Presentation to City of Seattle  
**DESIGN REVIEW BOARD — RECOMMENDATION MEETING**

DPD # 3010926

# 2030 8th Avenue

June 22, 2010

“Hot Buttons”

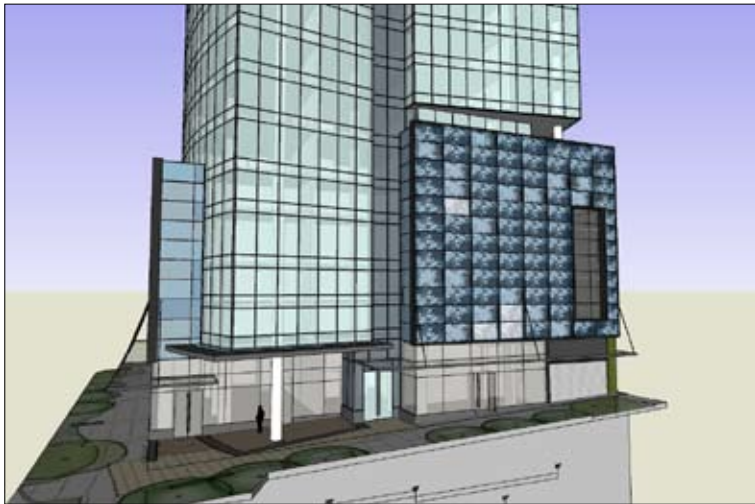
- *The site location at the edge of the downtown towers and the location within the platting pattern mean that the proposed development will be visible for a very long time. The applicant has a responsibility to carefully integrate the tower and the base designs, and create a human scale at and near the street level.*

- *Challenge of cladding above-grade parking with application of a human scale material.*

- *Consider relocating storage from the 5th/6th levels to another area, and using those levels to provide open space and views to the future park across the street*

- *Create a rhythmic façade in human scaled materials and details that relate to the residential and architectural context of the area*

- *Create a cohesive design, integrating a human scale at the base and corner entry with the scale of the tower above.*

The revised base massing includes a three story difference of the two “shoulder” forms along Lenora and 8th. These elements are held back from the corner to allow the tower to ground itself. Careful integration of the tower with the base help the structure transition from high-rise massing to human scaled proportions. Careful treatment of the façade and base massing keep the eye moving across the façade and transitioning from the proposed building to neighboring context.

With the addition of work studios, and associated decks, sliding doors and operable window vents, the base façade has many human scale elements. The frame of metal panel is broken down into small horizontal bands, rather than large scale panels. The glass façade within the frame mixes vision, translucent and spandrel glass to provide a mix of depth perception and opacity. This will create an active façade both day and night.

Storage has been shifted from a full floorplate at level 5 and half floorplate at level 6, to be 3 half levels at levels 5-7 on the south side, allowing the north base façade to drop a story along Lenora, per board guidance. See the answer to B-3, and the stacking diagrams for levels 5-7 for more information.

The design team has worked to provide rhythmic elements without creating a false representation of programmatic elements, or faux “bays” that don't have meaning. These rhythms translate from landscape to architecture, to architectural detailing.

The project team took cues from the Braille Library's Lenora street exposed columns. We restructured our column alignment along Lenora to become regularly spaced, per board guidance. However, the design team did not want to emulate the exposed colonnade, because the two column rhythms would clash and become overbearing on the streetscape.

Following the board's desire to better animate and activate the Lenora Street side, the corner retail entry has been moved to the mid-point of the Lenora façade.

### C-5 Encourage overhead weather protection.

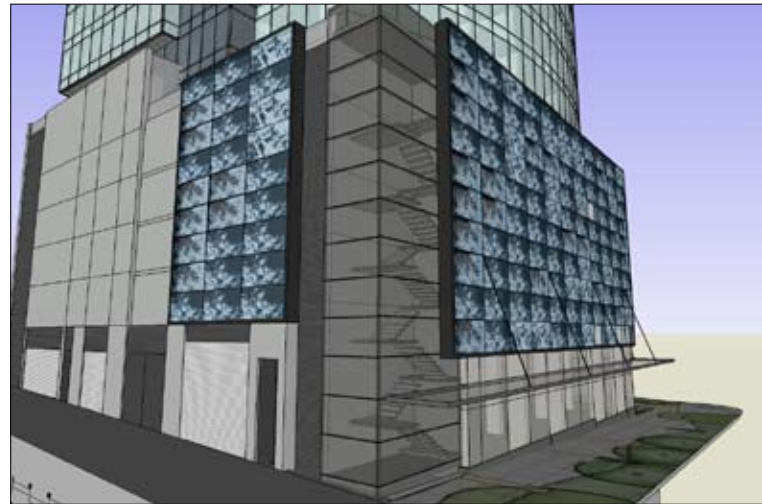
*"The corner canopy may need some attention to create overhead weather protection that is low enough to be functional and at human scale, while also relating to the overall tower expression at that corner."*

The design team has crafted a canopy design that responds to the building massing and site topography, signifies the main residential entrance, and provides 100% coverage with a simple, elegant layout.

Because of structural reasons, as well as architectural, the design scheme proposes a high canopy at the corner of 8th and Lenora. However, this corner canopy has been lowered to 19 feet, from the EDG proposal of 22 feet, which is now comparable height to, or lower than, many downtown "feature" canopies. Due to sidewalk grades and the desire to not visually break the flanking canopies along 8th and Lenora, the additional four feet of height (over code maximum 15 feet — see departure request) being requested for the corner canopy allows for an adequate change in plane of the grouping of canopies.

The design team has also expanded the coverage to be a minimum extension of 8 feet, average of over 10 feet and maximum of 15 feet at the corner. This exceeds the code requirement of 8 feet from the building face. Therefore, the additional height has been counteracted by additional canopy width.
